**H22-19**  
**Hotel Redevelopment**  
***REVISED***

Property Owner: Legacy Hotel of Medina LLC  
Applicant: Jim Gerspacher  
Location: 253 and 257 South Court Street  
Zoning: C-2 (Central Business)  
Request: Certificate of Appropriateness revisions for the construction of a hotel

The current application revises the footprint and height of the hotel building, updates building elevations, and provides greater detail. The proposed revision does not alter the previous approval regarding the demolition of two existing buildings at 253 and 257 South Court Street or application H24-06.

This letter is regarding the proposed hotel on parcel 028-19A-21-397. Our team has been working on adjustments to the overall building design to improve constructability, enhance the floor plans for both operational efficiency and guest experience, as well as enhance the exterior design and compatibility within the Historic District.

ELEVATION HOTEL - WEST ELEVATION  
1" = 10'-0"

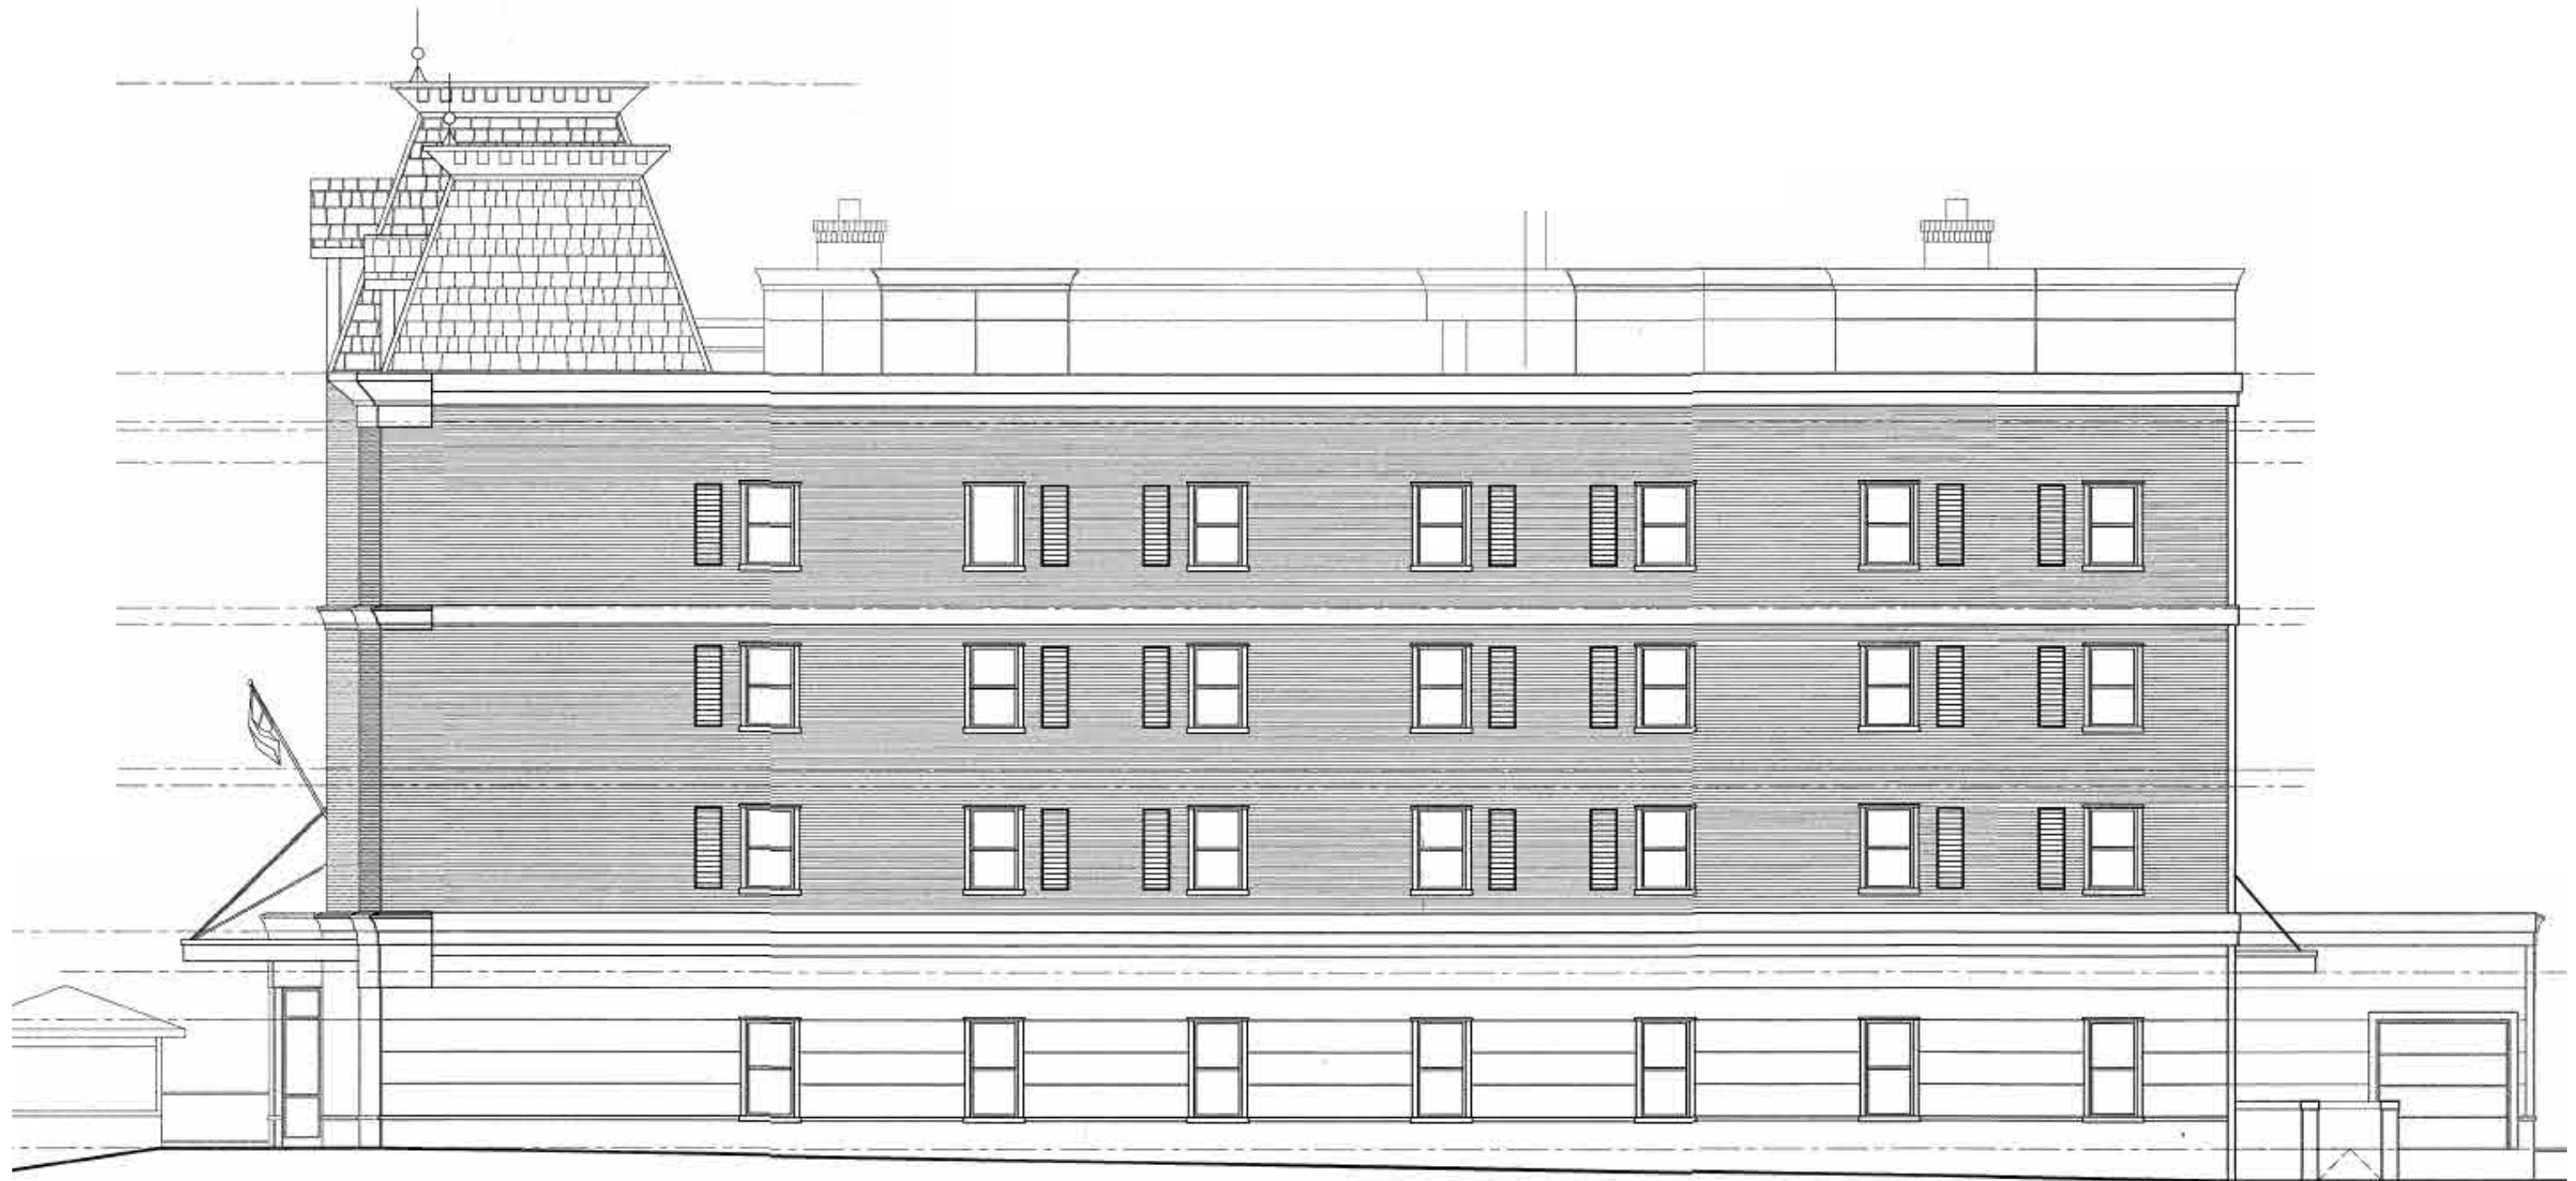
The rear elevation has been revised to remove a first floor ramp and doors. Doors have been added to the side elevation on the first floor.

1 ELEVATION HOTEL - SOUTH ELEVATION  
1" = 10'-0"

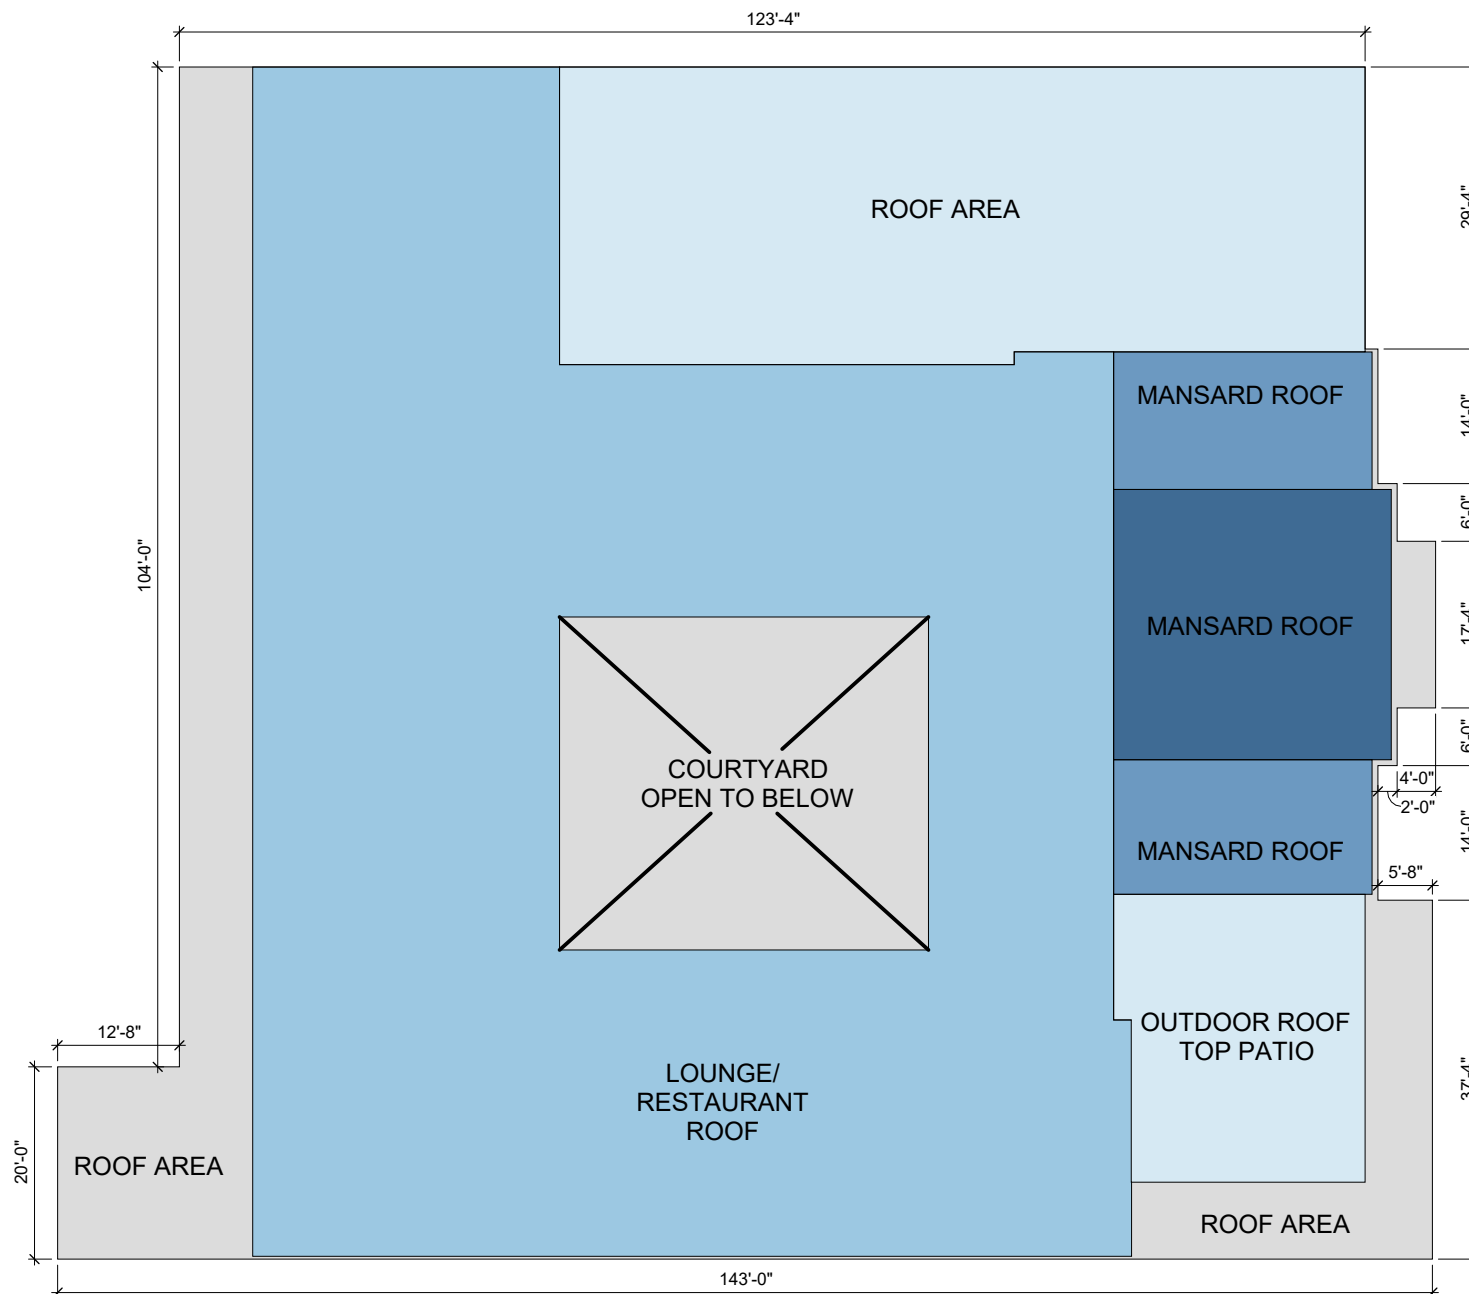
As requested, this is a brief balcony description: The new "observation deck" is a balcony feature added on the south façade of the fifth floor, serving the "Sky Lounge" not only as a balcony, but also as an extension when the full height glass door system is fully open. The crescent shaped balcony has an area of 175 sf , with 3'-0" at the narrow sides and 5'3" in the middle. The face of the balcony will be painted navy (SW 0032 Needlepoint Navy) to match the cornice, it will also have dark bronze aluminum guard with glass at 42" high.
